# BS 9999:2008 & BS 8300:2009

## Impacts on Accessibility Design in Ireland & Implications for ISO Accessibility & Fire Safety Standards

### 1. Introduction

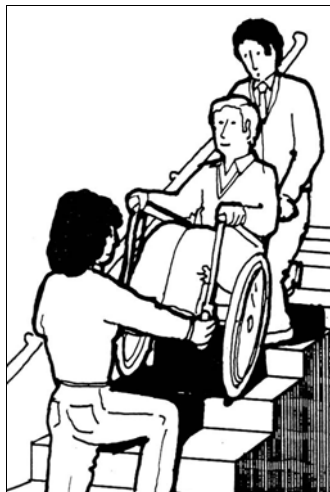
- Although in **Wheelchair Users** (Paragraph #46.3 on Page 247), it is stated ...
  - 'It should be noted that it can take as many as four people to use an evacuation chair safely and effectively.'

... the dimensions for the minimum width of staircases in ***Width of Escape Stairs*** (Table 14 on Page 88) and ***Firefighting Stairs*** (Paragraph #21.3.2 on Page 106) disregard the guidance given on Page 247 ... and ignore the minimum staircase width (**1.5m**) required to safely assist the evacuation of a person in a manual wheelchair ...

And ... for some unexplained reason, handrails **are** permitted to intrude into the 'clear width' of a firefighting staircase in BS 9999:2008 (Paragraph #21.3.2, Page 106).

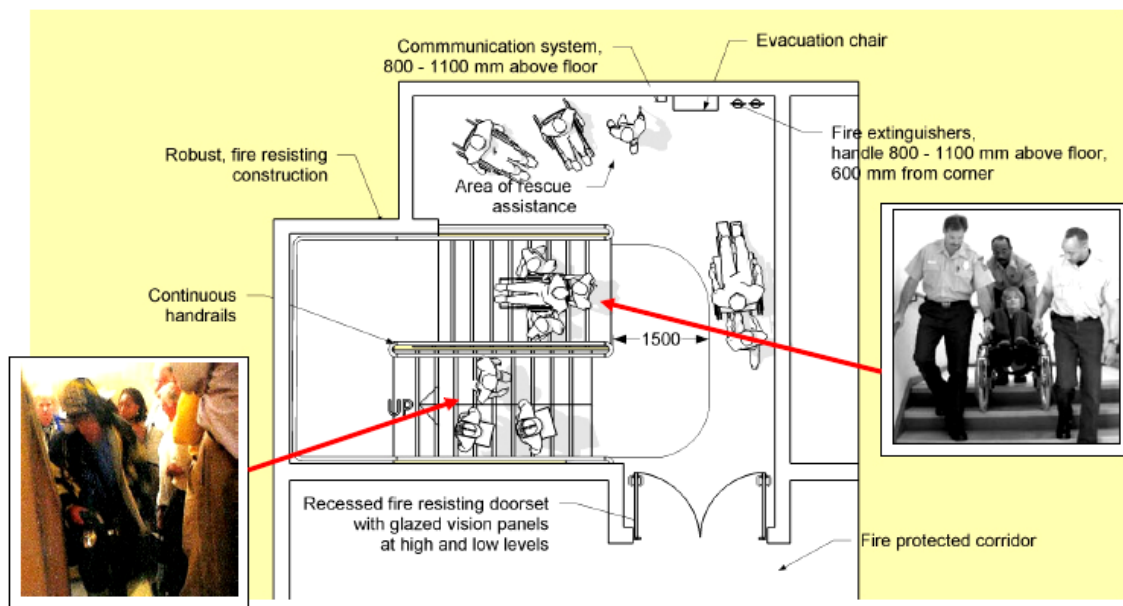
- **Contraflow Circulation**, i.e. the simultaneous emergency access by firefighters into a building and towards a fire, while building users are still moving away from the fire and evacuating the building, has not been considered at all in BS 9999:2008.

A staircase width of **1.5m** provides sufficient space for a mobile person to evacuate (700 mm) and a heavily protected and equipped firefighter to simultaneously move in the opposite direction (800 mm) ...
